Architectural Review and  
Historic Preservation Board  
Agenda Report

File: AR 19-09

RE: Architectural Review 19-09 (The Humboldt)- 23-unit multi-family housing  
development, 1991 Humboldt Road, APN 002-110-034

ARCHITECTURAL SITE PLAN

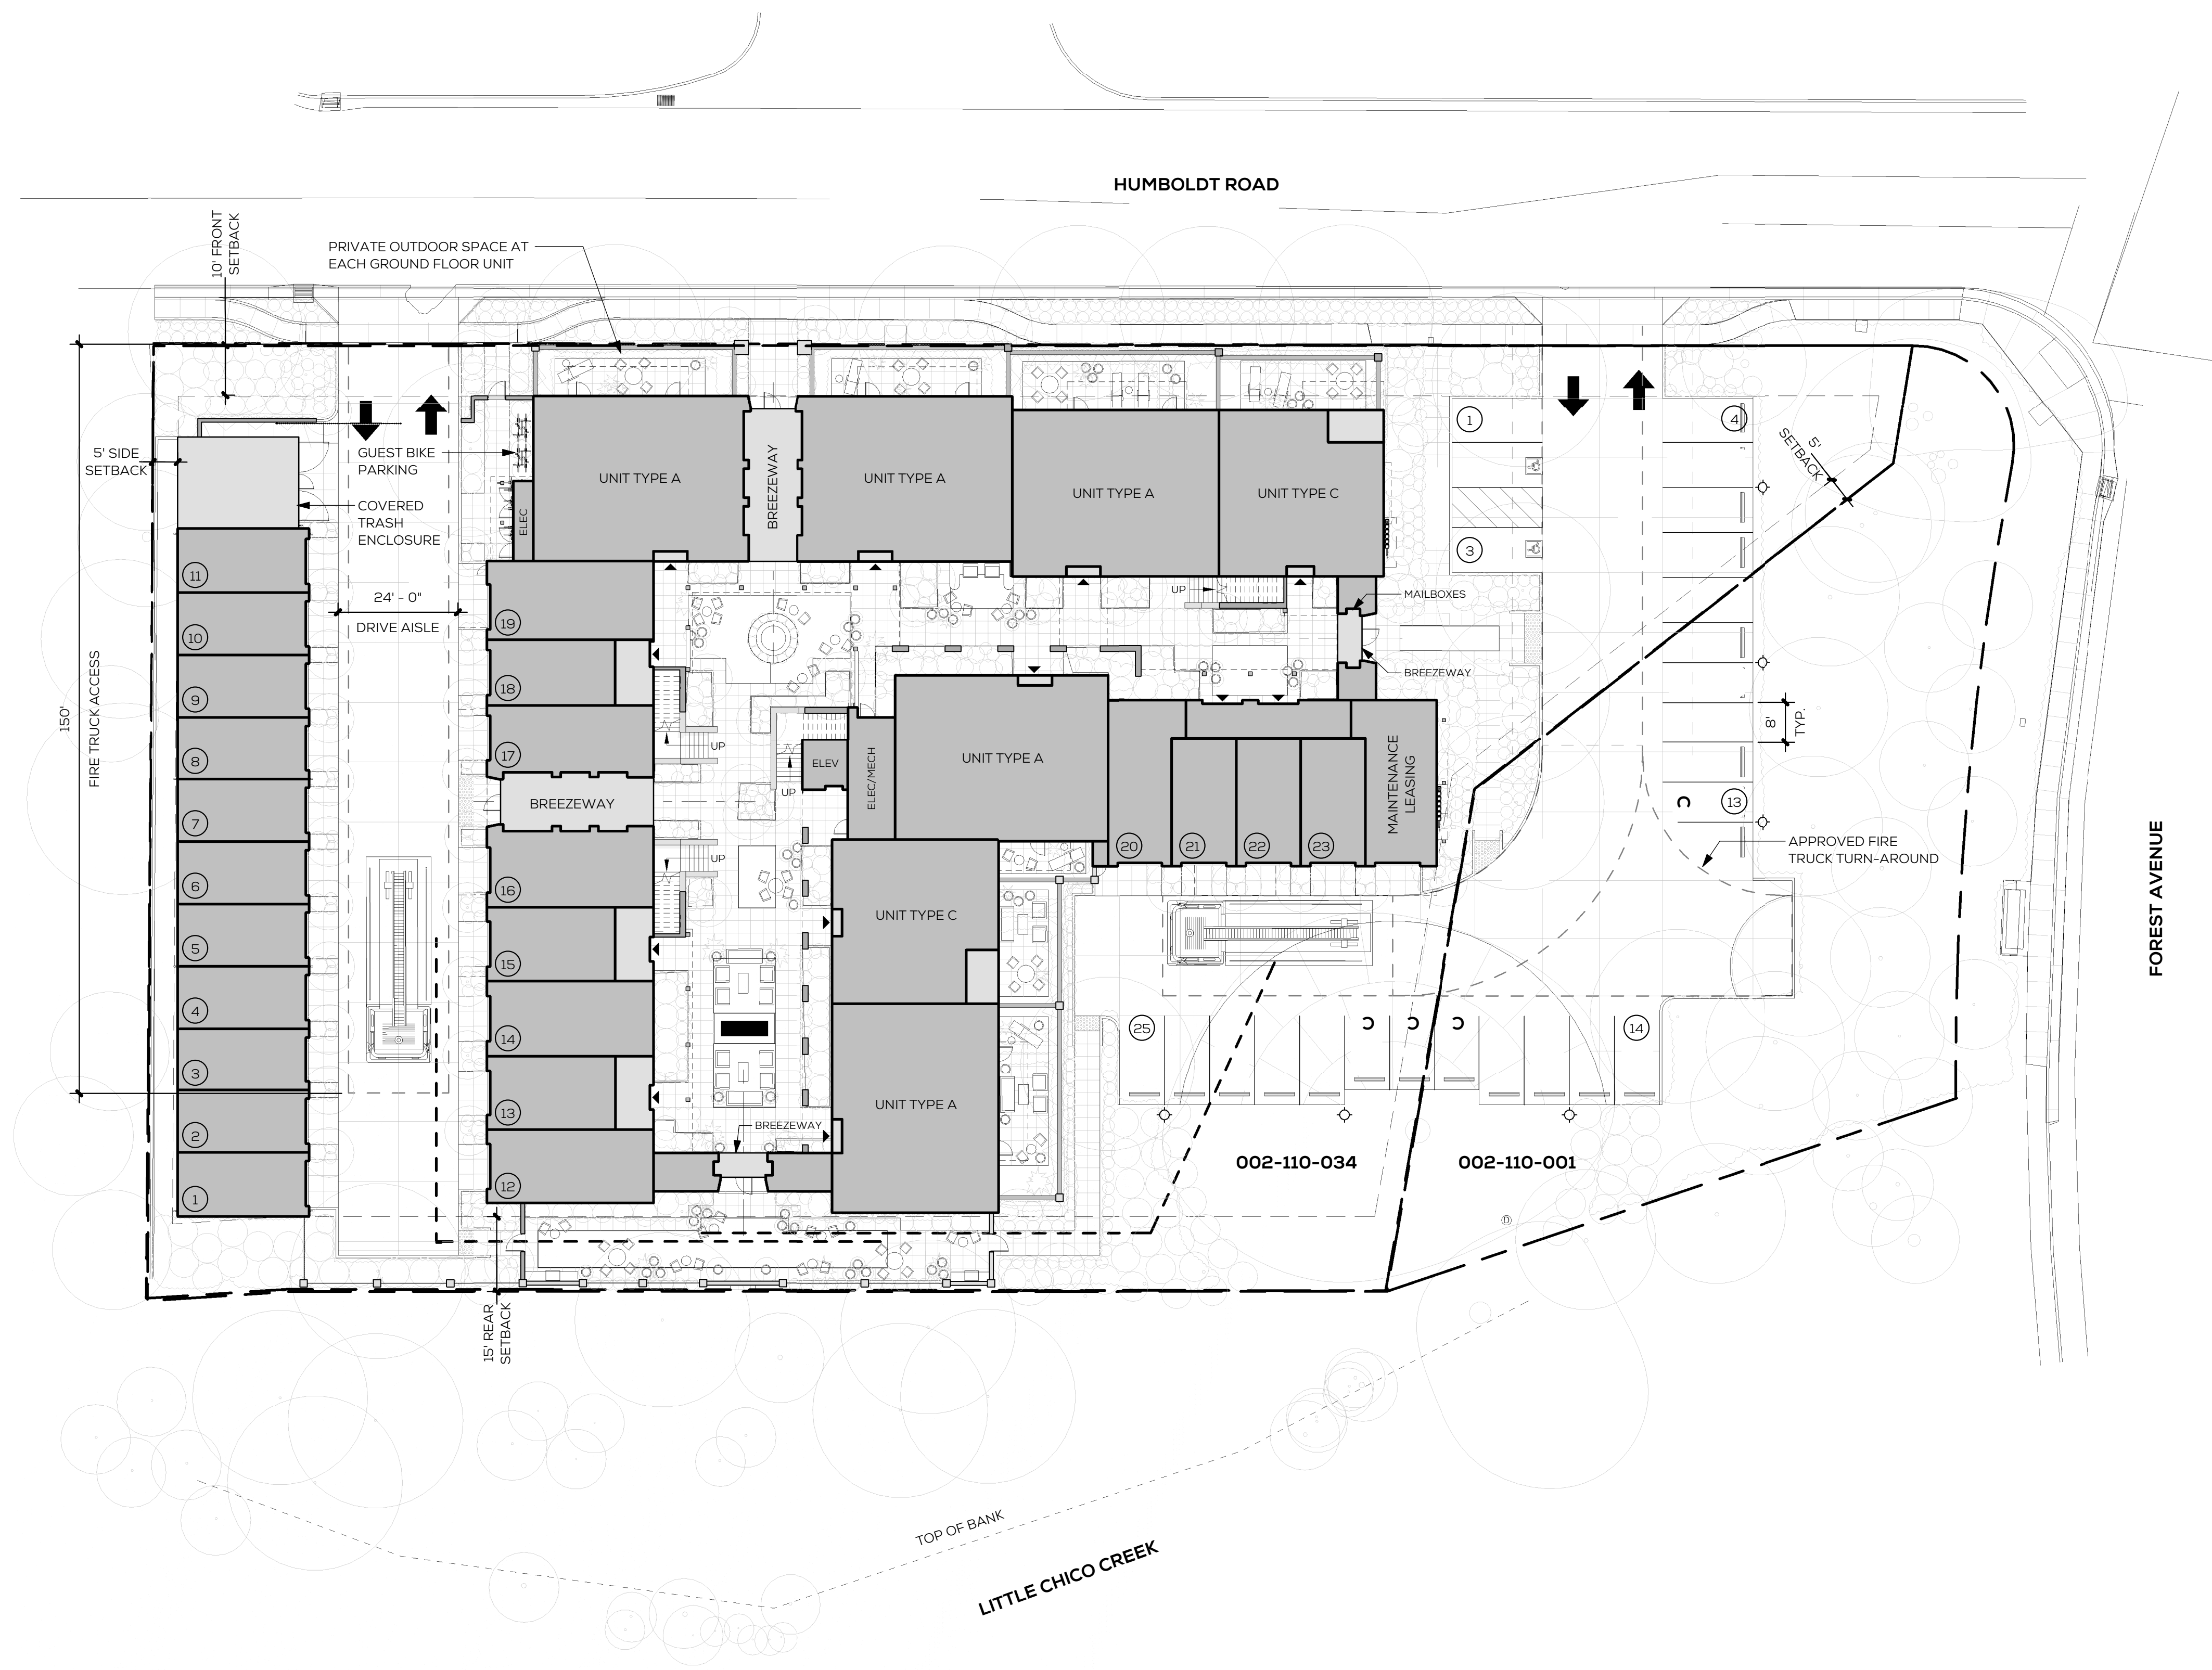
The site plan depicts the proposed layout of the site (see **Attachment B**, Overall Site Plan). Residential buildings would be organized in an "L-shape", forming a central courtyard between the buildings. The central bulk of the buildings would be three stories in height, tapering down to two-story buildings. A single-story parking garage would be positioned along the westerly property line. The easterly portion of the site is City-owned right-of-way, and uncovered parking is authorized in this area through a Grant of License, approved by the City Council on

The buildings are oriented such that they form an “L-shape”, with a central courtyard in the middle. Entry to the buildings is provided by several secured breezeways on all sides of the building site to the courtyard area. Entry to the residential units is provided within the courtyard, either by ground-level entries, or by an exterior staircase. Residential amenities are provided within the courtyard area, including extensive seating areas, barbeques and outdoor fireplace. Portions of the complex fronting Humboldt Avenue are setback ten feet, providing private outdoor space for ground-floor units. The rear portion of the buildings are setback 15-feet from the rear property line, providing additional seating areas to view and enjoy Little Chico Creek. The detached garage structure positioned along the easterly property line is set back five-feet. The garage structure is 15 feet tall and would function as a screen between the proposed project and existing single-family home to the west.

The parking layout is such that the apartment complex is central to the site, with garage parking to the west and uncovered parking to the east. A total of 27 bicycle parking spaces are provided on site, including two U-shaped bicycle racks located toward the easterly vehicle entry, and within private garages. A total of 48 vehicle parking spaces are provided on site, including 23 garages spaces and 25 uncovered parking spaces. The code typically requires 35 off-street spaces for the proposed mix of units and bedrooms, including guest parking. Chico Municipal Code 19.70.040.F requires that parking spaces which exceed the minimum number of spaces required by more than 35-percent may be allowed when a combination of additional landscaping, pedestrian/bicycle improvements, and/or pervious surfaces are provided. Given the layout of the proposed parking area away from the public right-of-way and abundant landscape screening of the parking area, staff supports the proposed parking.

A/1 CONCEPTUAL LANDSCAPE PLAN  
 SCALE 1" = 16'0"

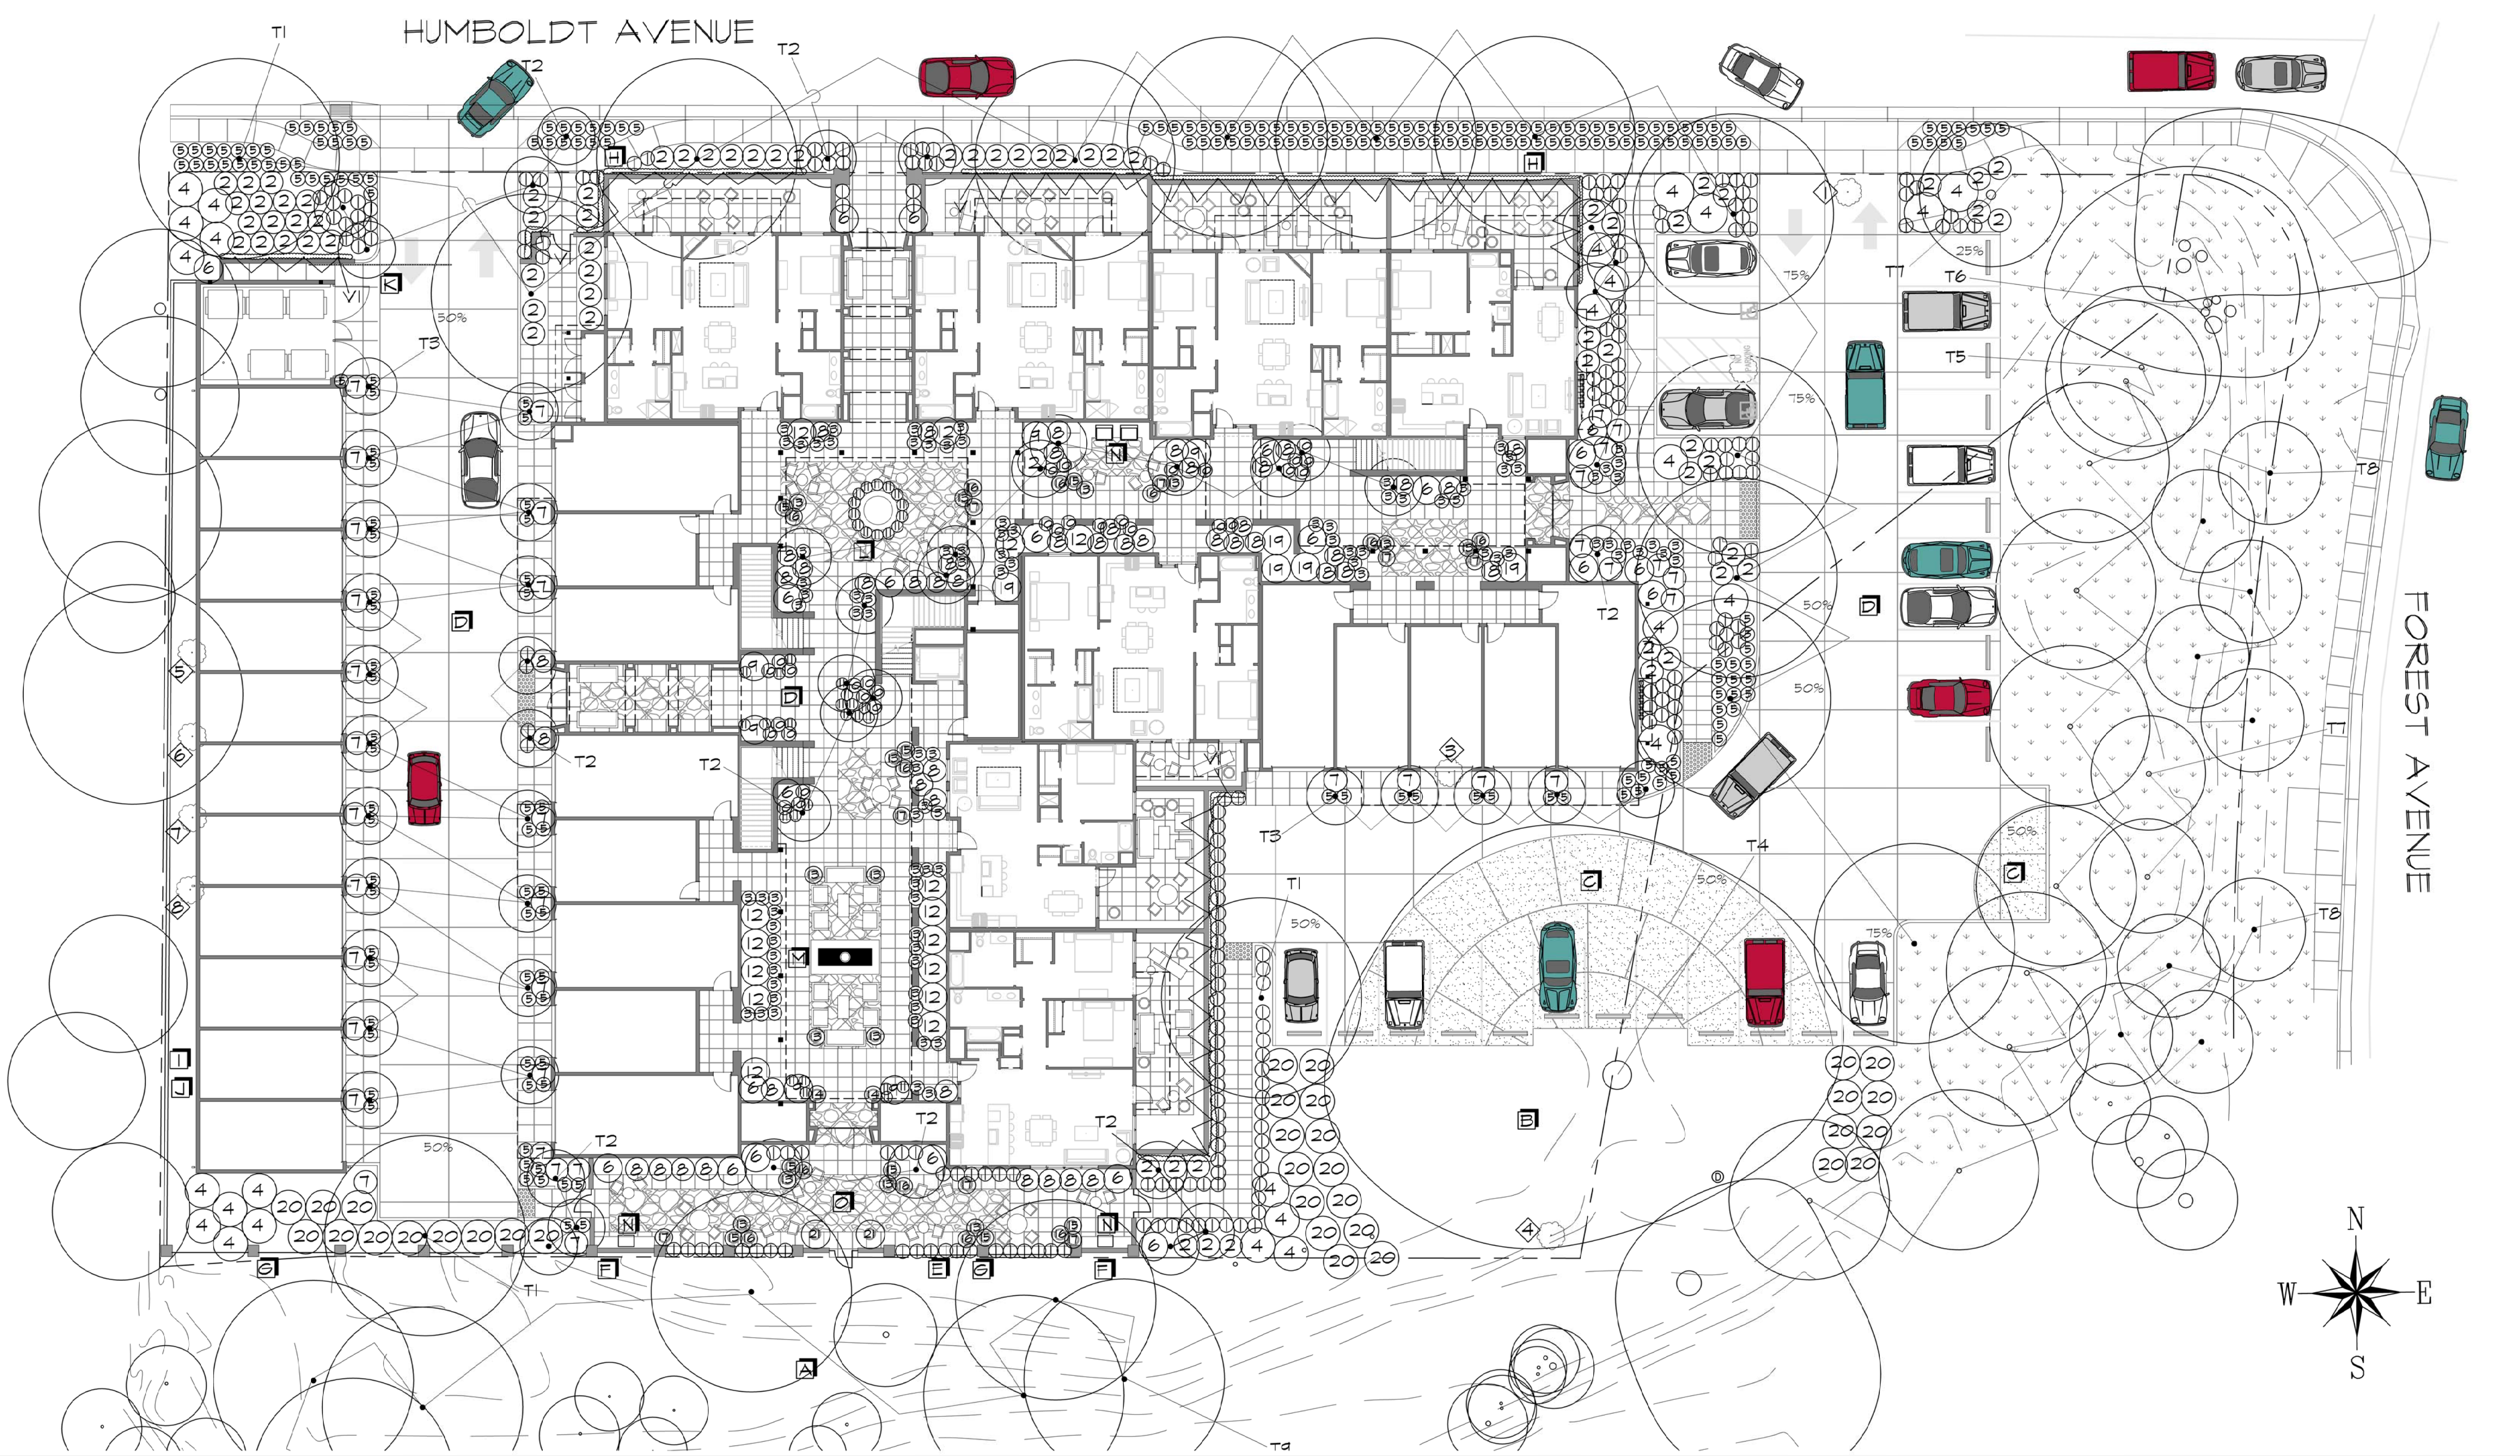
The proposed landscape plan calls for retention of a large valley oak tree located near the

southerly property line. To ensure retention of the tree, and to comply with the City's Tree Preservation Regulations (Chico Municipal Code (CMC) 16.66), a condition of approval is recommended that would require the applicant to submit a tree protection plan to the City's Urban Forest Manager prior to any site disturbance (see condition of approval #2(e)). A total of eight trees would be removed from the project site, including three which qualify for mitigation pursuant to CMC 16.66 (Tree Preservation Regulations).

The landscape plans call for a variety of species with moderate to low water demands (see **Attachment E**, Landscape Plans). A mixture of trees, shrubs, and perennials are proposed around the new buildings, within the central courtyard and throughout the new parking area. A total of 76 new trees would be planted on site, including 38 parking lot shade trees and 38 landscape trees. Parking lot shade is estimated to reach 53-percent at full tree maturity, and would include a mixture of Chinese pistache, redwood and Arizona cypress trees. A variety of plants and groundcover would be incorporated within the courtyard area, as well as along the Humboldt Avenue frontage.

- e. All trees not approved for removal shall be preserved on and adjacent to the project site. A tree preservation plan, including fencing around drip lines and methods for excavation within the drip lines of protected trees to be preserved shall be prepared by the project developer pursuant to CMC 16.66.110 and 19.68.060 for review and approval by planning staff prior to any ground-disturbing activities.
